EXAMINATION REPORT - 50 321/OL-89-03

Facility Name: E. I. Hatch Nuclear Plant

PLANT E. I. HATCH
Reactor Operator and Senior Operator
Written License Examination Utility Comments
October 9, 1989

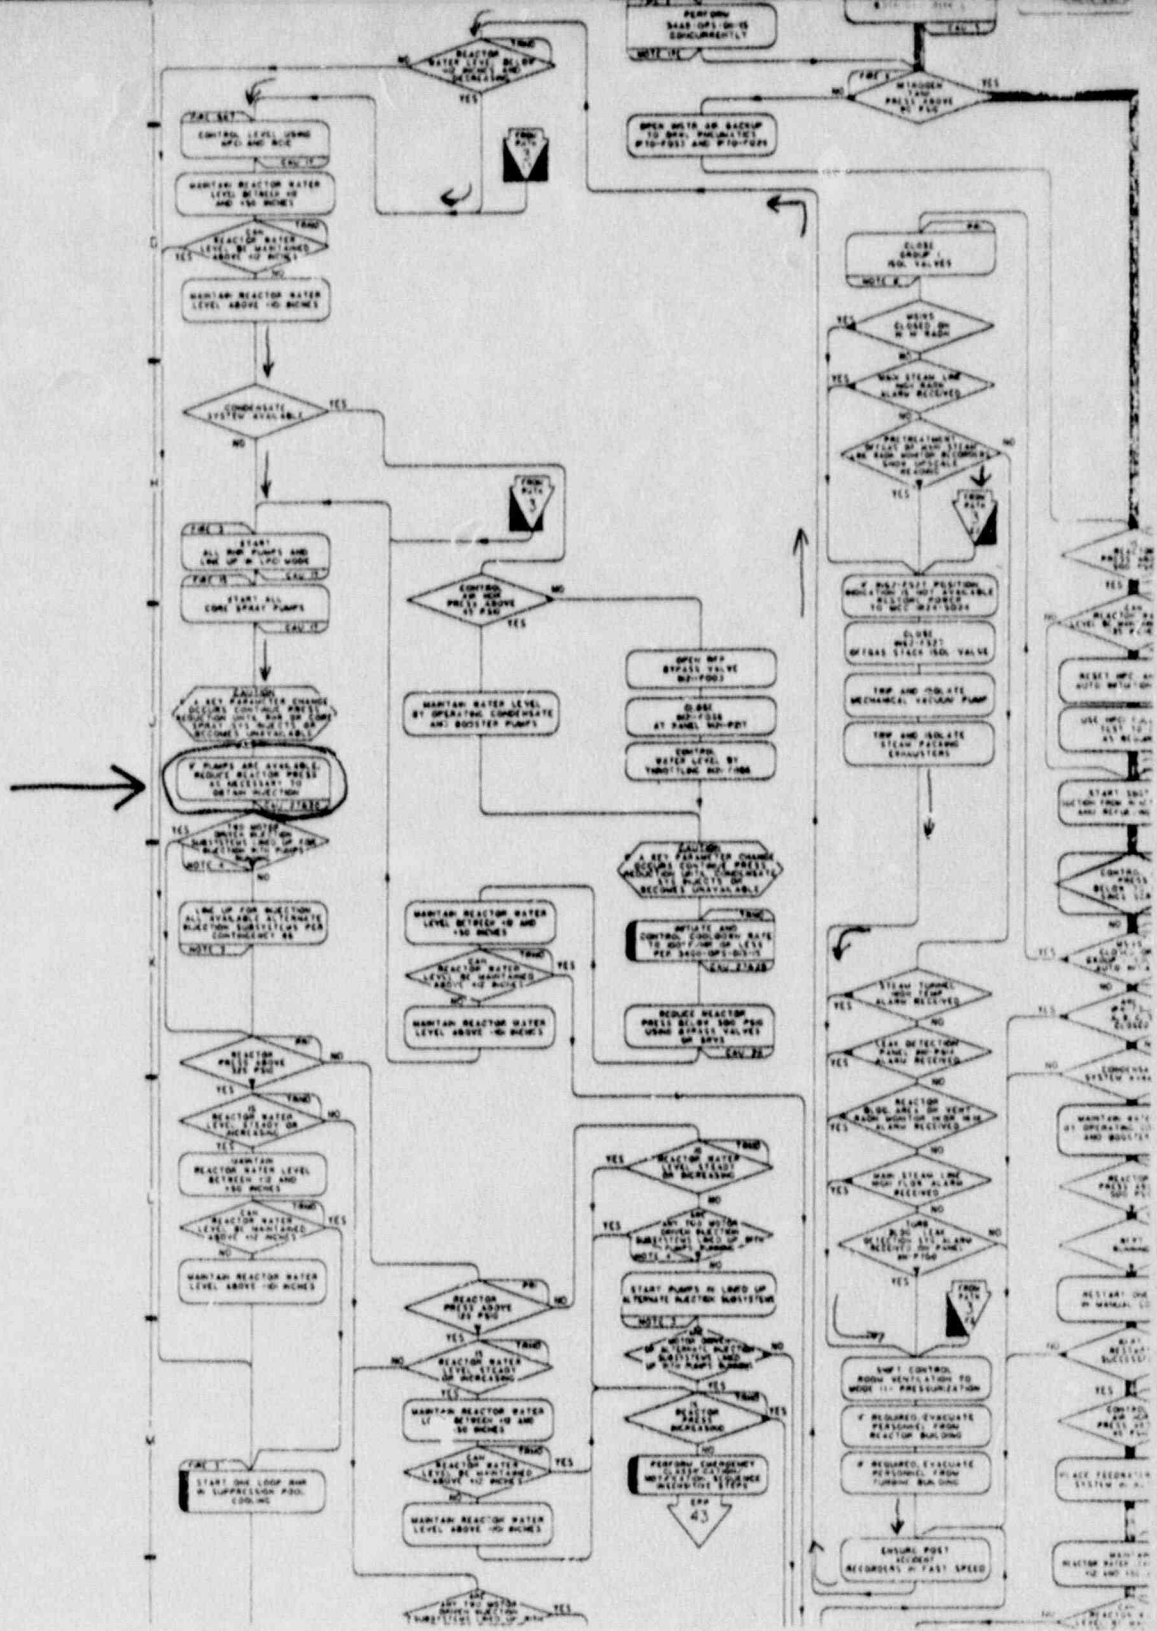
QUESTION 2.01/5.06

Question was not contained in the exam at the time of the Pre Exam Review. Stem of question states that a LOCA is in progress. If this is true the operator should have entered path five not path four as indicated in question.

The answer given in answer key appears to be answering the question, "Under what conditions may the RPV Cooldown Limit of 100°F per hour be exceeded?", not the question given. The actual reason for the step J0 on path four is to reduce reactor pressure to below the shut off head of the Low Pressure Injection Systems to allow for reactor water level restoration. The rad protection discussed in the answer key was actually accomplished by steps other than J0.

The required answer is not supported by referenced objectives.

RECOMMENDATION: Delete question.
